145 kV CAPACITOR VOLTAGE TRANSFORMER TYPE: CPB-H 145

END CUSTOMER:
APTRANSCO

LIST OF DOCUMENTS FOR CPB-H 145 TYPE CVT

6096769/2022/EEMRT-ENE51 FOR 132kV CAPACITOR VOLTAGE TRANSFORMERS

General Arrangement Drawing

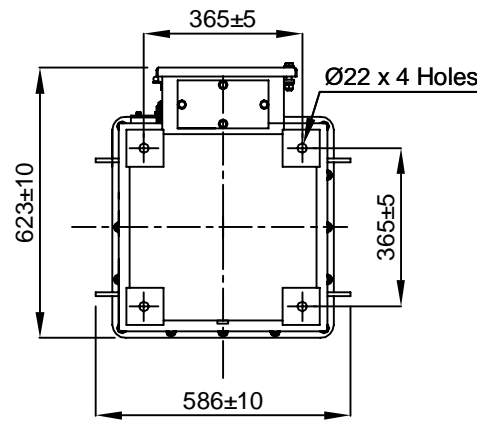
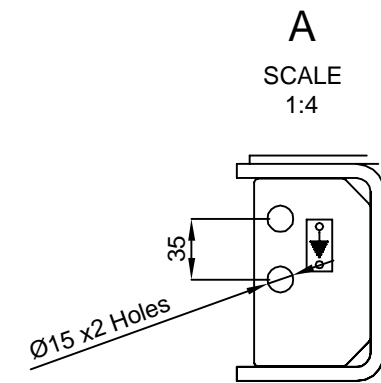
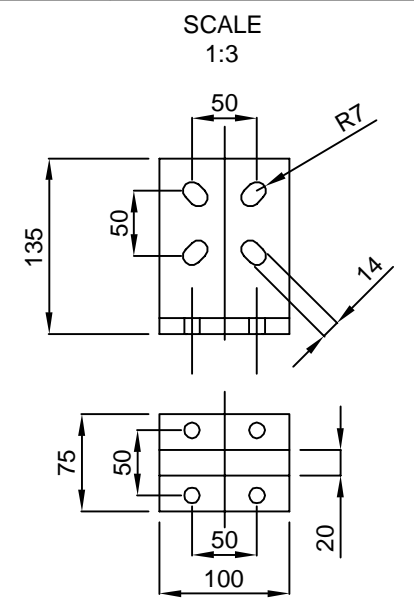
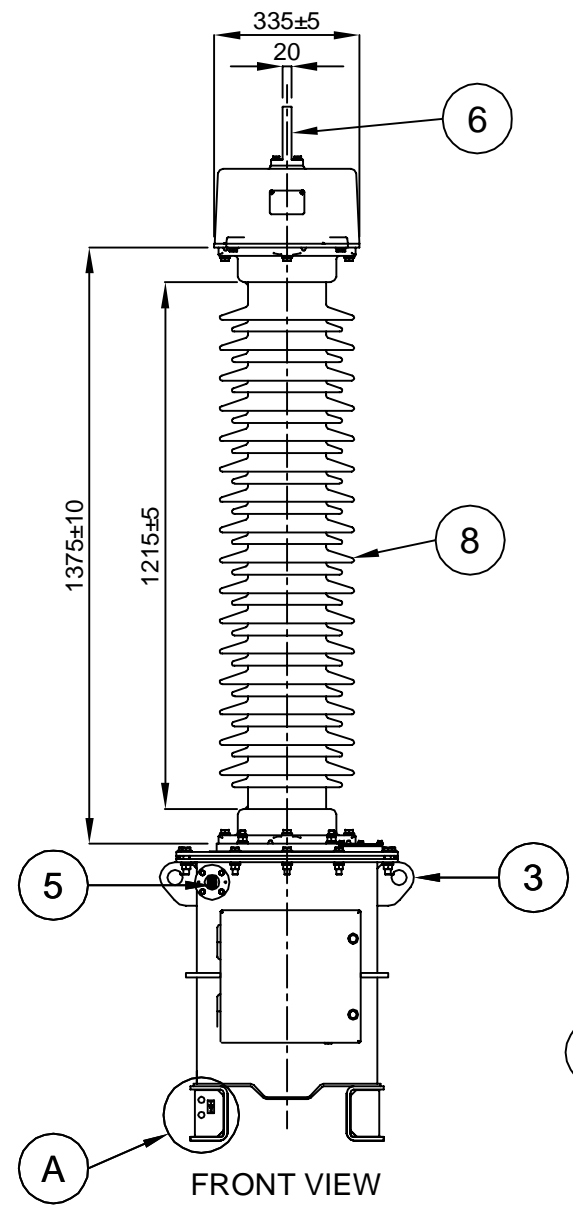
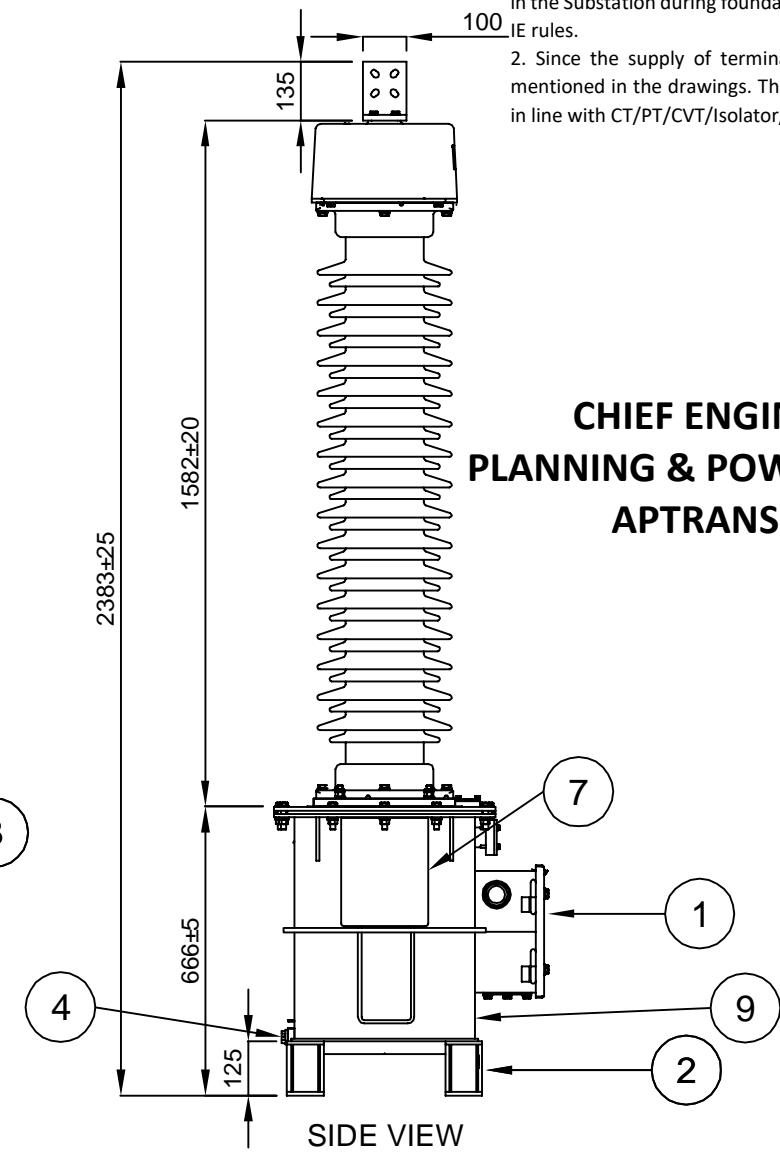
NOTE: 1. DRAWING APPROVAL SUBJECT TO VALID TYPE TEST REPORTS, TO BE CHECKED DURING ACCEPTANCE TESTS
2. FOR EPC CONTRACTS ONLY

1. Minimum 300mm plinth shall be maintained for CT/PT/CVT/Isolators/IV/LA/Breakers in the Substation during foundation works to ensure safe live to ground clearance as per IE rules.
2. Since the supply of terminal connectors is not in the scope of manufacturer as mentioned in the drawings. The EPC contractor shall be instructed to supply the same in line with CT/PT/CVT/Isolator/IVT/LA/Breakers requirement and compatibility.

Rating & Diagram Plate for
145kV Capacitor Voltage
Transformer

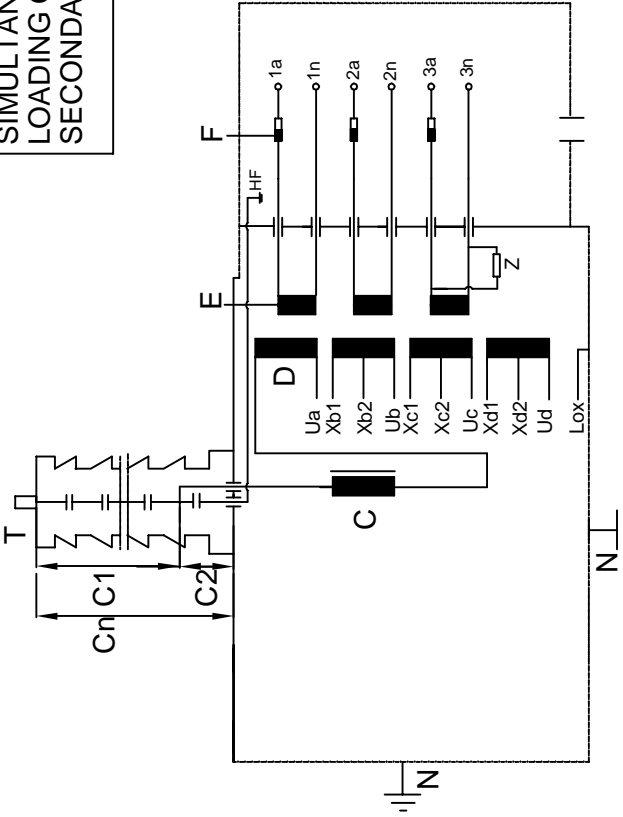
- Minimum 300mm plinth shall be maintained for CT/PT/CVT/Isolators/IV/LA/Breakers in the Substation during foundation works to ensure safe live to ground clearance as per IE rules.
- Since the supply of terminal connectors is not in the scope of manufacturer as mentioned in the drawings. The EPC contractor shall be instructed to supply the same in line with CT/PT/CVT/Isolator/IVT/LA/Breakers requirement and compatibility.

NOTE: 1. DRAWING APPROVAL SUBJECT TO VALID TYPE TEST REPORTS, TO BE CHECKED DURING ACCEPTANCE TESTS
 2. FOR EPC CONTRACTS ONLY

Revision		145 KV Capacitor Voltage Transformer Type: CPB-H 145	SECONDARY TERMINAL BOX	DRAWN: SR	CHECKED: SNP	APPRD.: SN	file: 3320-054	TOTAL SH. 1
A	2022-06-09			HITACHI ENERGY INDIA LIMITED (FORMERLY KNOWN AS APPSIL)			1HYT903320-054	
B	2022-06-28

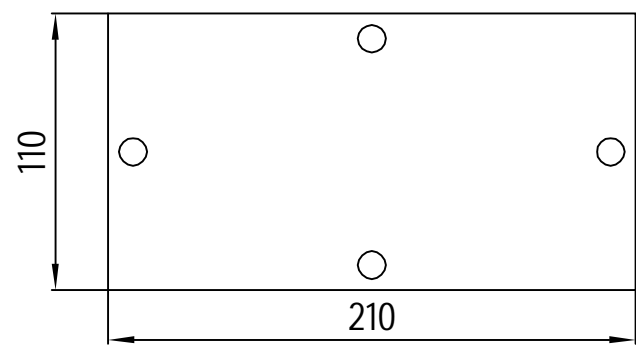
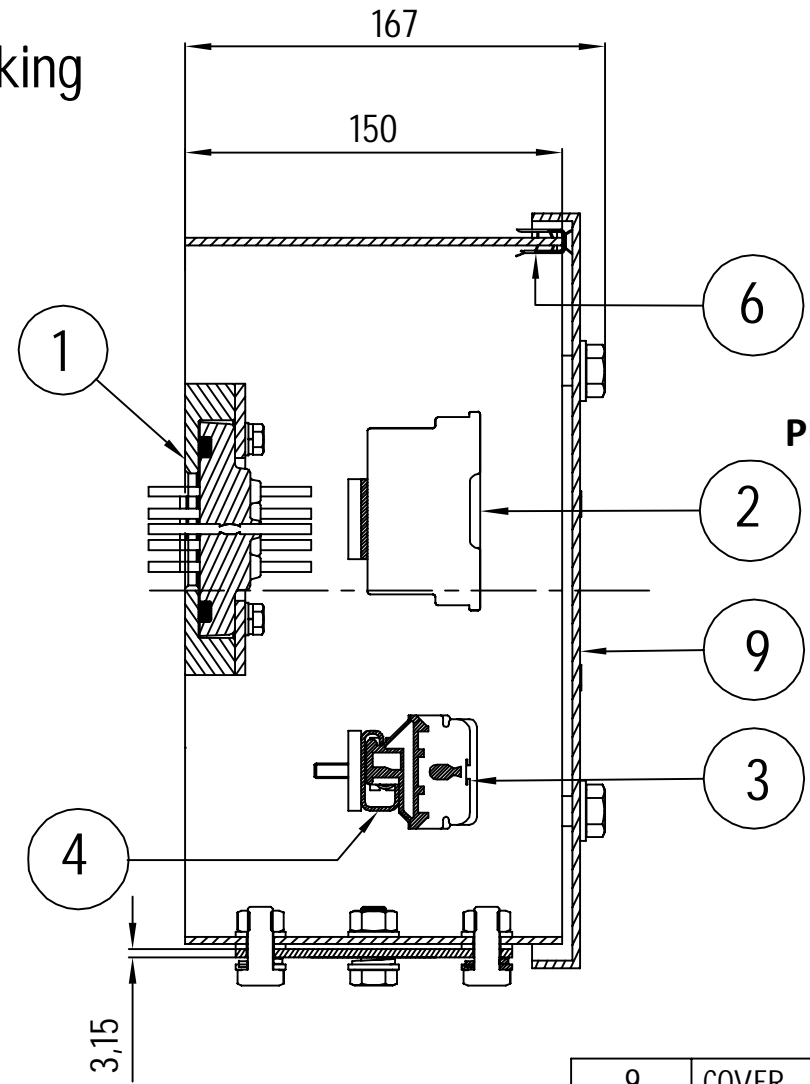
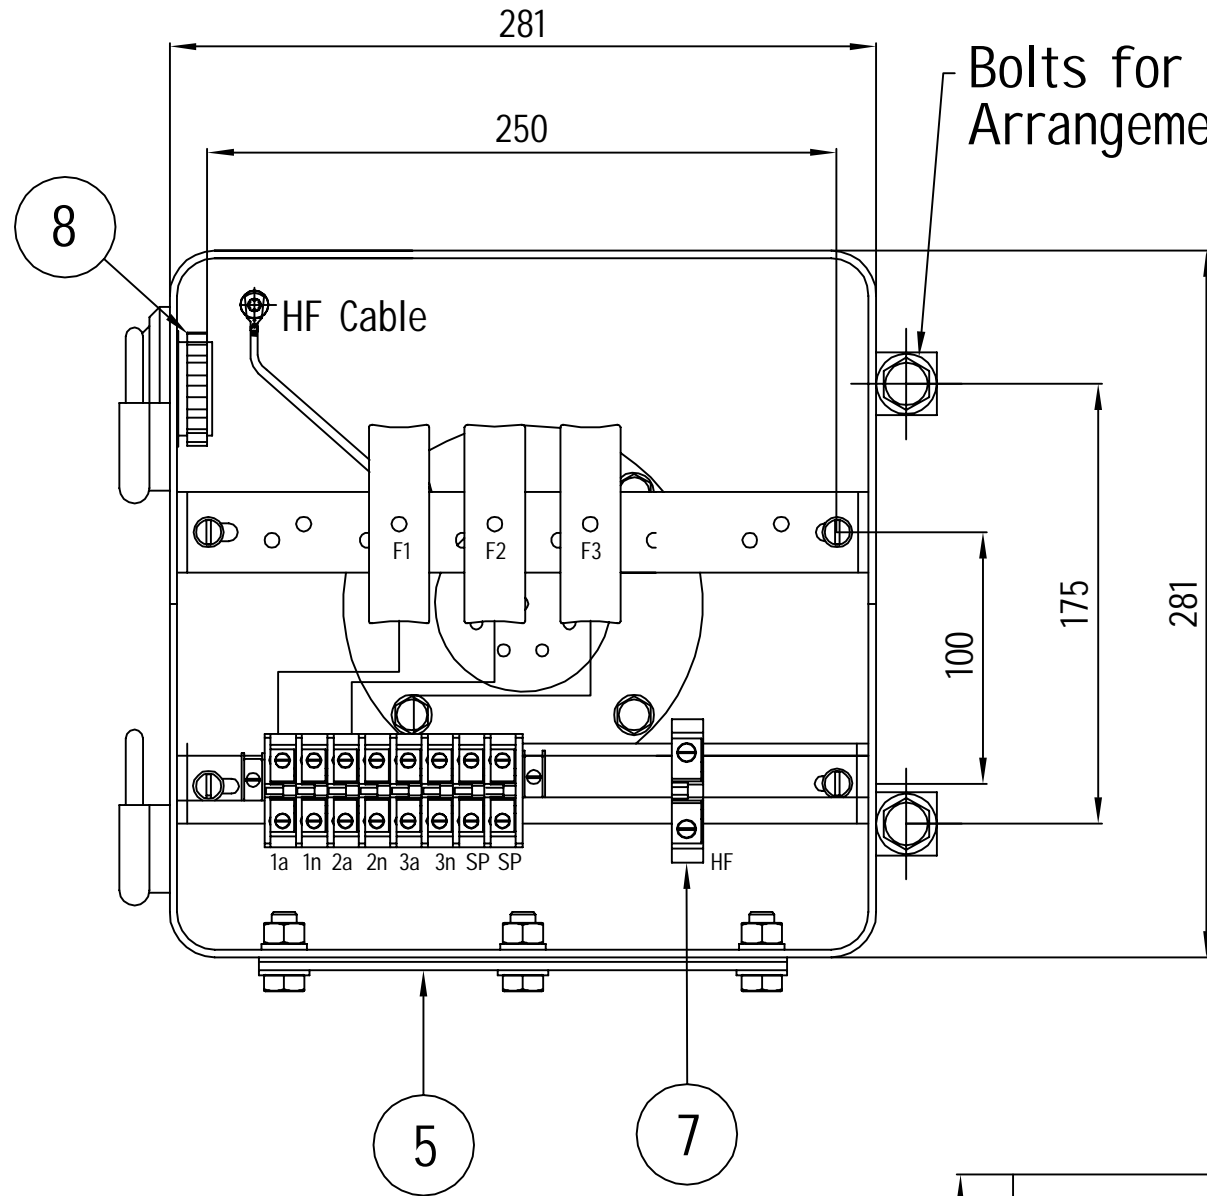
NOTE: 1. DRAWING APPROVAL SUBJECT TO VALID TYPE TEST REPORTS, TO BE CHECKED DURING ACCEPTANCE TESTS
2. FOR EPC CONTRACTS ONLY

SECTIONAL VIEW

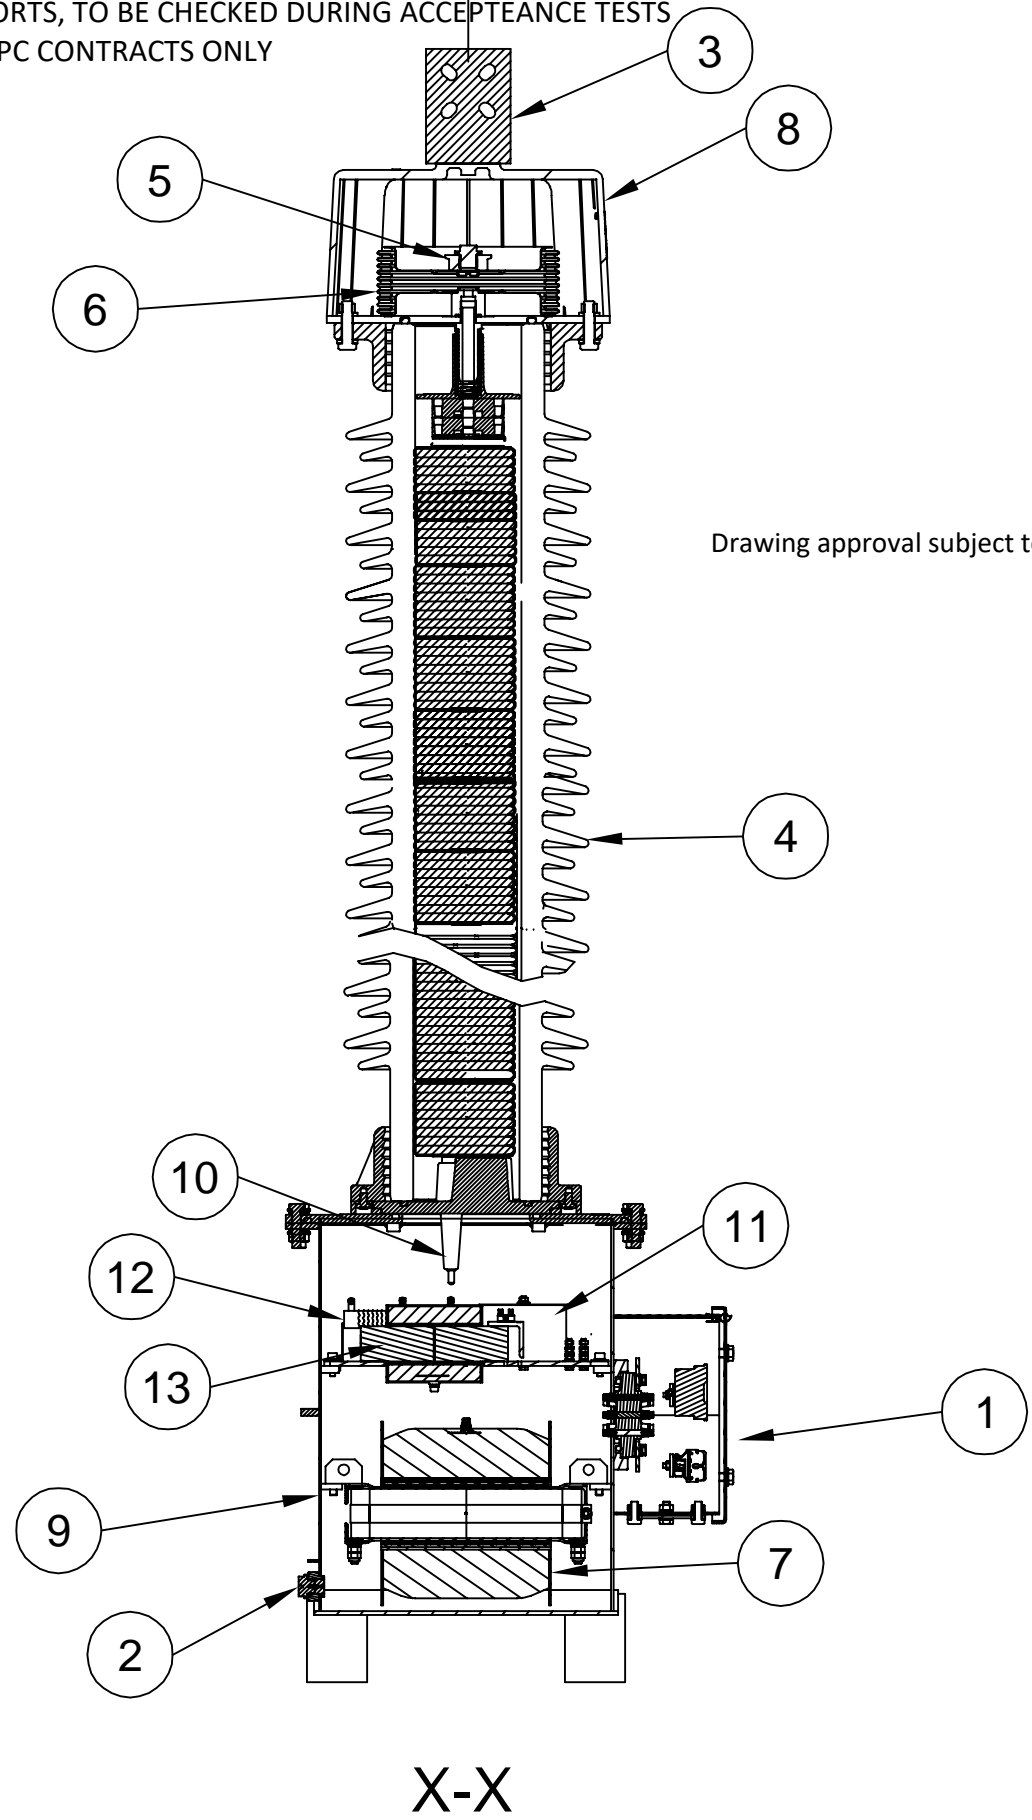
NOTE: 1. DRAWING APPROVAL SUBJECT TO VALID TYPE TEST REPORTS, TO BE CHECKED DURING ACCEPTANCE TESTS
2. FOR EPC CONTRACTS ONLY

Revision		145 kV Capacitor Voltage Transformer Type: CPB-H 145	INSULATOR DRAWING (25 mm/kV)	DRAWN: SR	CHECKED: PDS	APPRD.: SN	file: - 3320-068	TOTAL SH. 1
A	2022-06-09			ABB HITACHI ENERGY INDIA LIMITED (FORMERLY KNOWN AS APPSIL)	1HYT903320-068		Sh. NO. 1	
B	2022-06-29

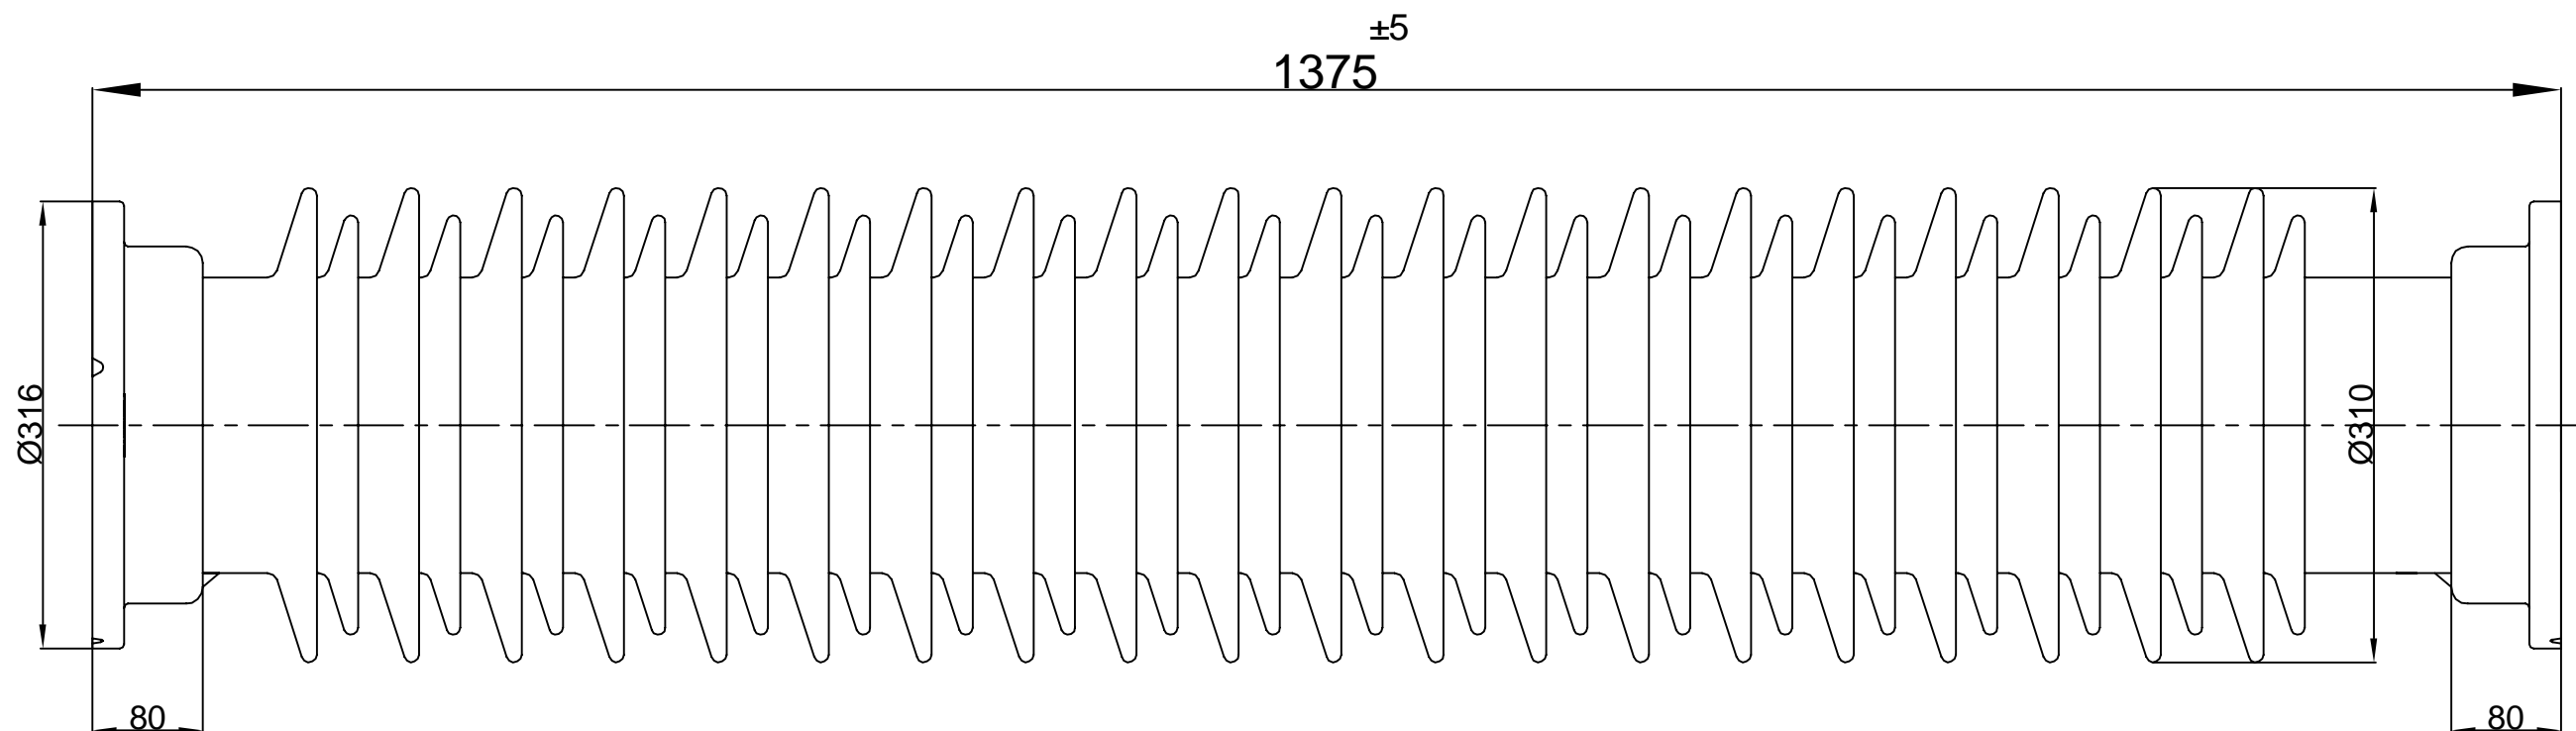
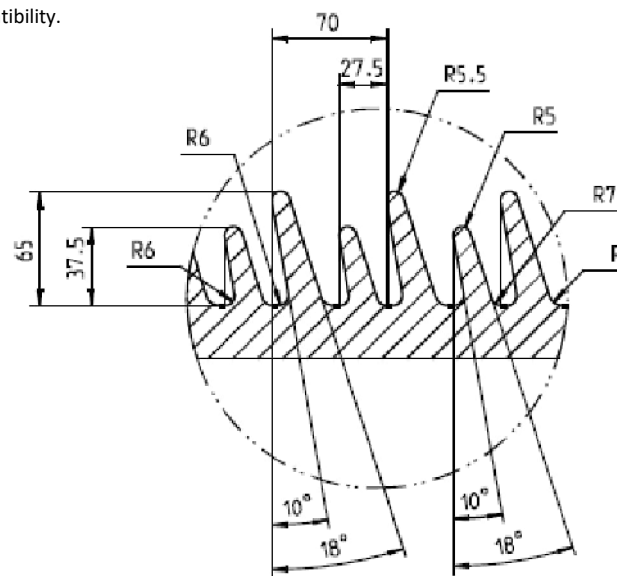
NOTE: 1. DRAWING APPROVAL SUBJECT TO VALID TYPE TEST REPORTS, TO BE CHECKED DURING ACCEPTANCE TESTS
2. FOR EPC CONTRACTS ONLY

1. Minimum 300mm plinth shall be maintained for CT/PT/CVT/Isolators/IV/LA/Breakers in the Substation during foundation works to ensure safe live to ground clearance as per IE rules.
2. Since the supply of terminal connectors is not in the scope of manufacturer as mentioned in the drawings. The EPC contractor shall be instructed to supply the same in line with CT/PT/CVT/Isolator/IVT/LA/Breakers requirement and compatibility.
